SERVICE BULLETIN

APPLICABILITY: 2015-20MY WRX and WRX STI

NUMBER: 12-305-20

SUBJECT: Front Hood Intake Duct- Design Change

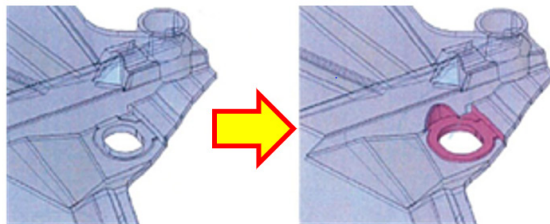
This bulletin announces a design change made to the front hood air intake duct used on the models listed above. The new duct utilizes larger holes at the attachment points to facilitate the use of mounting bolts with a larger shoulder (boss) diameter as shown (in green) in the illustrations below. For this reason, the new mounting bolts are not interchangeable and cannot be used with the original style duct.

- New Mounting Bolt: **901020030**
- New Duct-Inner Front Hood: **57253VA011**
